UNITED STATES ENVIRONMENTAL PROTECTION AGENCY
REGION IX
75 Hawthorne Street
San Francisco, CA 94105

Re: April 27 and April 30, 2009 Clean Water Act Inspection

NPDES COMPLIANCE EVALUATION INSPECTION

Facility: Satala Shipyard
P.O. Box 7684, Pago Pago, Tutuila Island, American Samoa
(NPDES Permit No. AS0020026)

Table 3.1 MYD Samoa Shipyard – Modified Additional BMPs for Dry Docks	
#1	The dry dock decks shall be sealed to the greatest extent practical in order to prevent the loss of solids into the harbor through gaps in the decking.

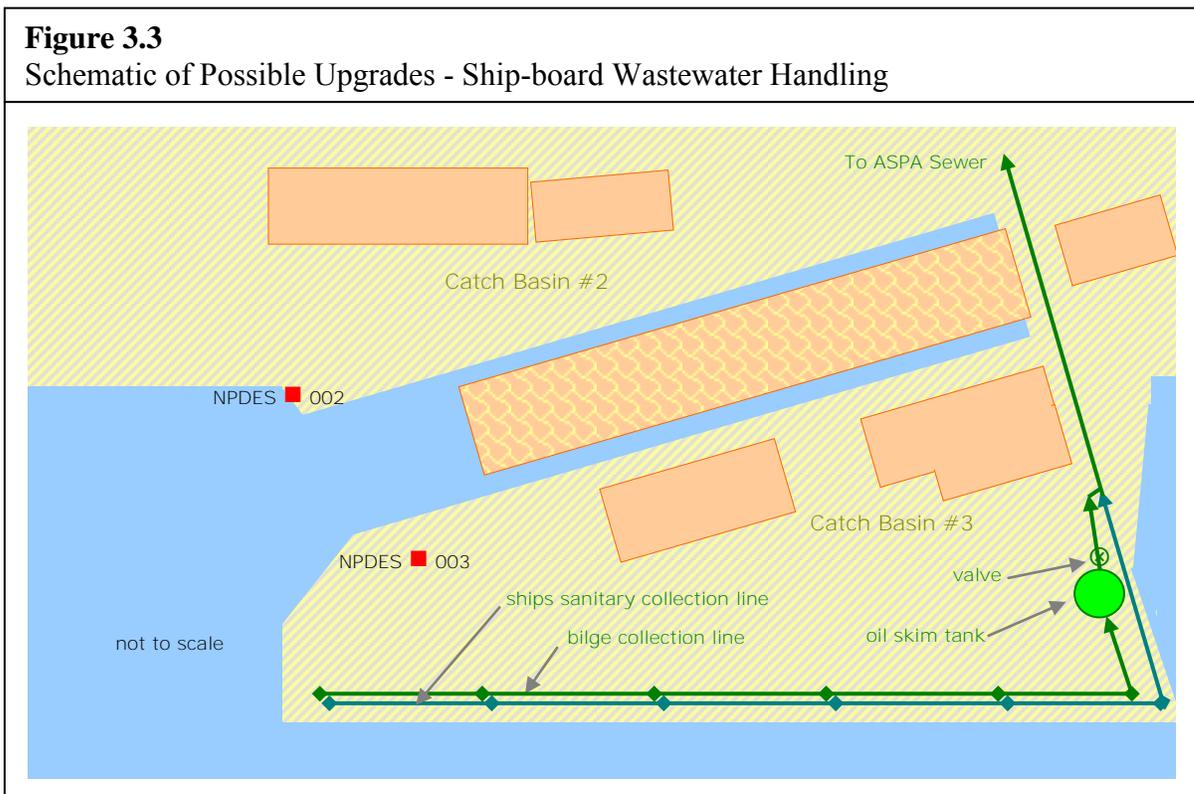
Corrective Actions - A few remaining shortcomings have been identified following the EPA Order. First, there were no curtains available to capture drifting solids within the dry dock for removal, although MYD Samoa had them on order. Second, process-related wastewaters (*hydroblast, hose cleaning, hydrotesting*) discharge uncontrolled from the dry dock deck to the harbor beneath. Additional BMPs to correct these shortcomings and to ensure the shipyard and dry dock remain swept, clean, and in order are listed in Table 3.1 on page 17.

#4	The dry dock deck shall not be rinsed off with water, nor shall water be used to collect spent blasting grit or remove solids from vessel exteriors.

#5	At the end of each shift, the capture of solids (<i>blasting grit, removed scale, trash, rust</i>), the removal of these solids from the dry dock deck through and broom or vacuum cleaning shall be done in order to prevent solids entrainment in storm water runoff.

#6	Hull hydroblasting shall occur only after the dry dock is broom or vacuum cleaned to prevent the wash down of contaminants (<i>solids, spills, oils, etc.</i>) with the tail waters.

#8	Hose cleaning and hydrotesting shall be <i>done pier side</i> so that tail waters drain into the harbor through one of the three NPDES permitted catch basin sumps.

#9	ASEPA shall be notified the day before any planned submergence of a dry dock; and the submergence shall not proceed until ASEPA has approved the condition of the dry dock and authorized its submergence in writing.

#10	The use of corrosion inhibitors (nitric-acid bearing) in wet sandblasting and the accumulation of hazardous wastes shall be prohibited.

Table 3.2 MYD Samoa Shipyard – Modified Additional BMPs for Shipyard Operations	
#11	Secondary containment always shall be deployed around all materials, paints, fuel, containers, drums, trash heaps, hazardous materials storage, tooling and mechanized equipment exposed to rainfall on the dry docks or on shore.

#12	Anodes and ballast shall be covered to prevent contact with rain and storm water runoff; spent anodes and ballast shall be contained within drums or sealed crates.

#13	Collected spent blasting grit shall be stored in a way that prevents contact with rainfall or storm water run-off.
#14	All captured runoff from contact with contamination sources either shall be treated through settling and oil skimming prior to discharge to the harbor or shall be directed into the domestic ASPA sewers.

#15	Pier side curbs along the harbor shall be maintained; pier side curbs surrounding the dry docks shall be built <i>if the landings are not maintained swept, cleaned, and in order</i> .

#16	There shall be self-certifications of no discharge to the harbor of fuel oil, oil sludge, oil refuse, bilge water, ballast waters, ships sanitary, or any other wastewaters from any vessel berthed at the shipyard or in dry dock.
